PROJECT: RSLEC EXHIBIT HALL DEMOLITION
RFP# 2019-03

Addendum 1 to RFP 2019-03 is a clarification of the work that is required by the RSCVA for the demolition of the Exhibit Hall.

ADDENDUM 1
February 4, 2019

BOLLARD DETAIL

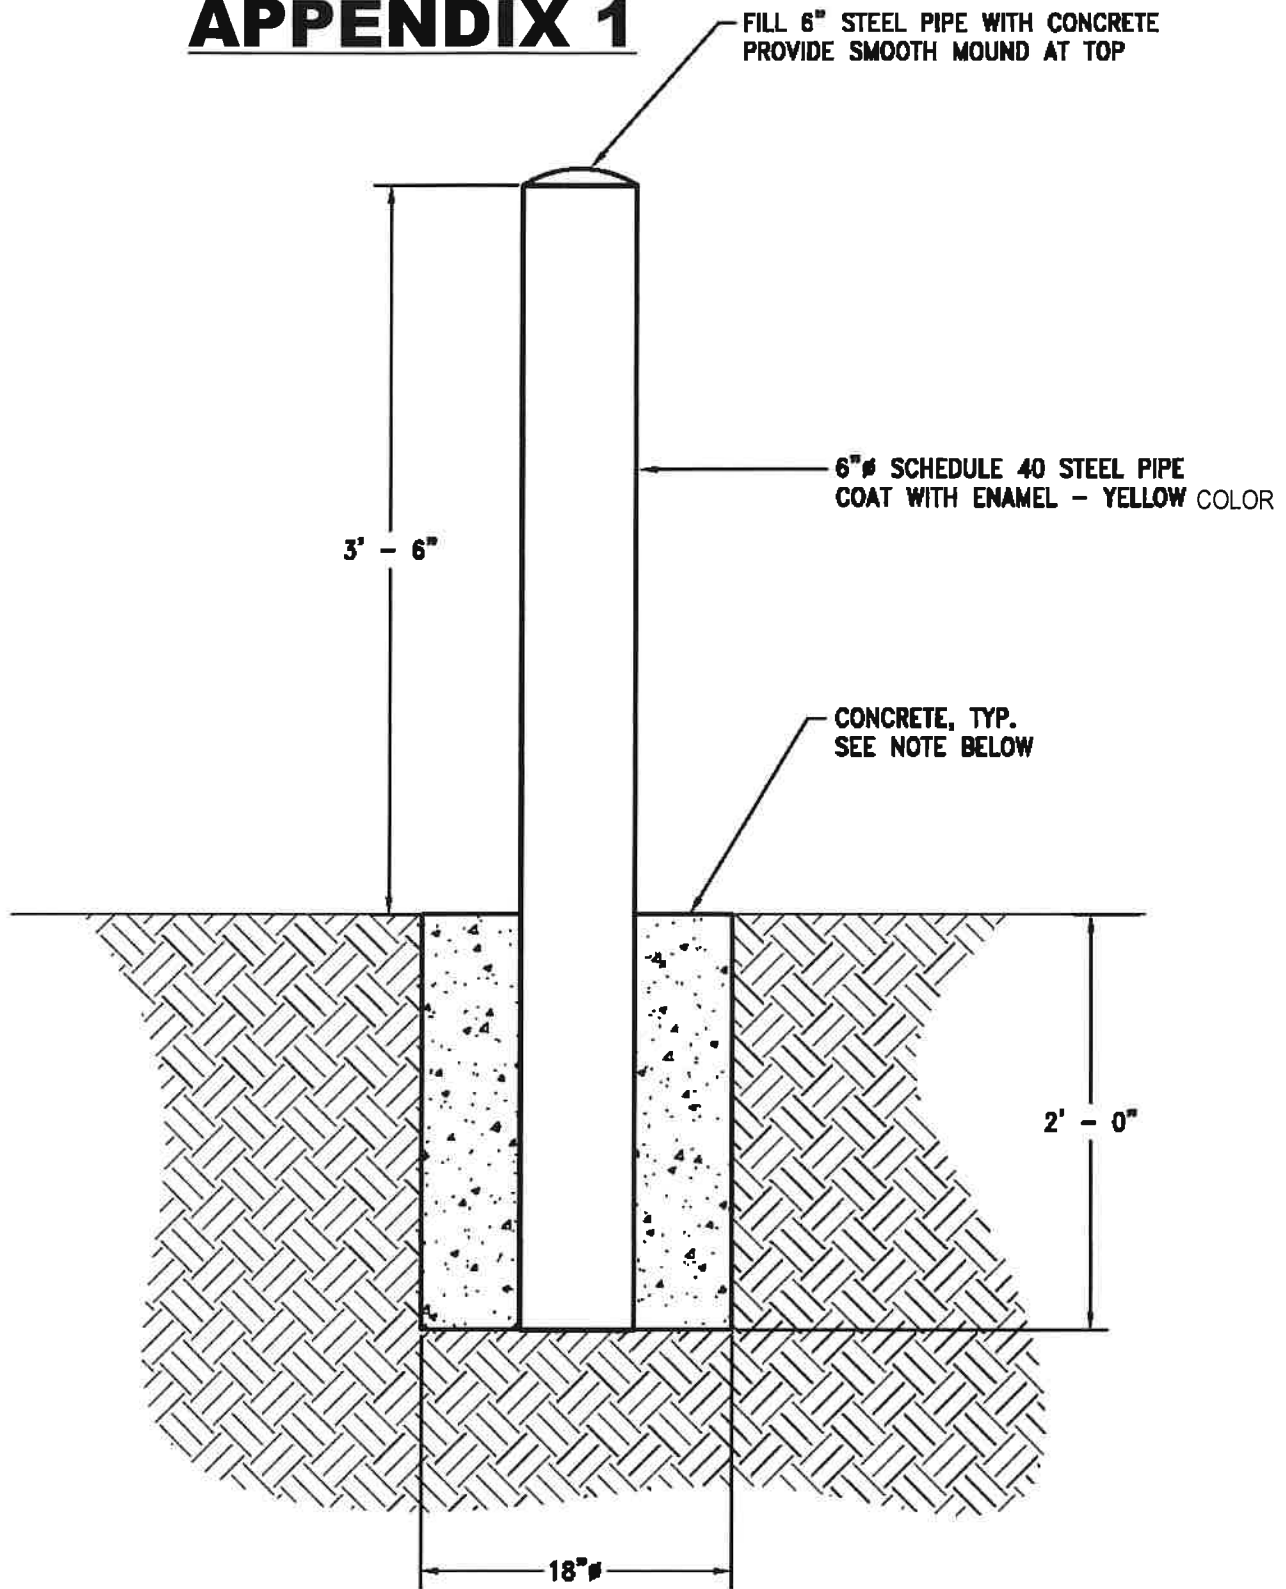
- C. It is required that bollards be installed to protect the utilities (Electrical/Water) on the east and west side of the Exhibit Hall as it is currently configured. See Appendix 1.

PORTLAND CEMENT CONCRETE (CONCRETE) SHALL HAVE THE FOLLOWING CHARACTERISTICS: 3,000 PSI MINIMUM COMPRESSIVE STRENGTH AT 28 DAYS, MINIMUM 6 SACKS OF CEMENT PER CUBIC YARD, SLUMP AT 1 TO 4 INCHES.
